Amendment
U.S. Patent Application No. 10/823,607

Amendment**U.S. Patent Application No. 10/823,607****Amendments to the Drawings:**

FIG 11

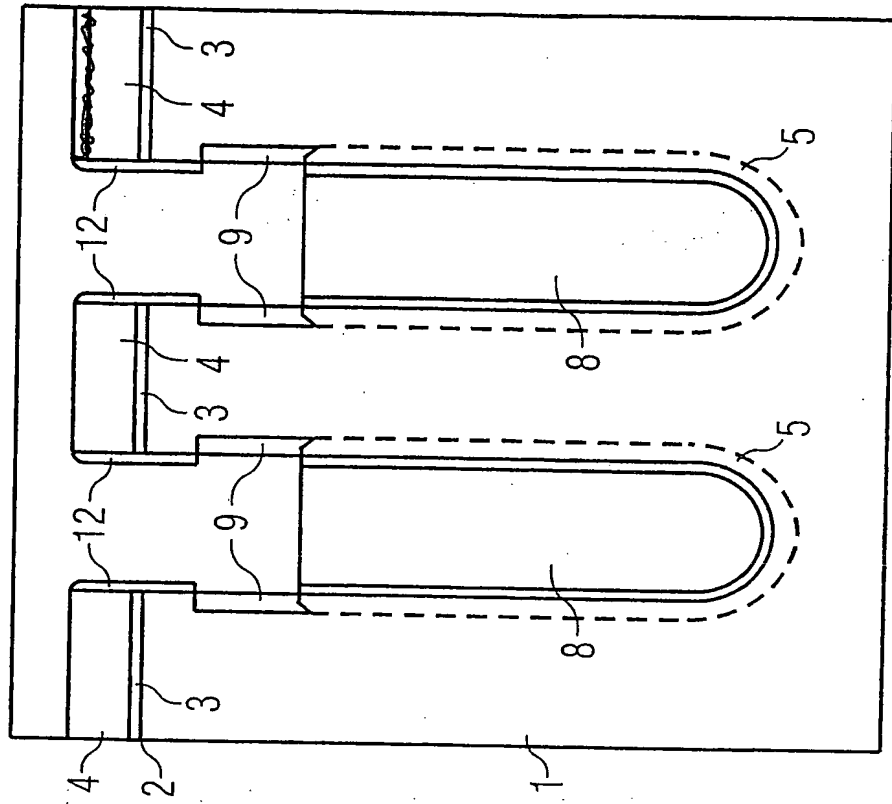
As noted above, Figs. 10 and 11 have been amended to remove horizontal portions of the silicon nitride layers 12 shown at the upper right hand corners of these figures. No new matter has been shown in these figures.

The attached sheets of drawings include changes to Figs. 10 and 11. In particular, the horizontal portion of the silicon nitride layer 12 shown at the upper right hand corner of each of Figures 10 and 11 has been removed to correspond with the other layers 12 shown in these figures.
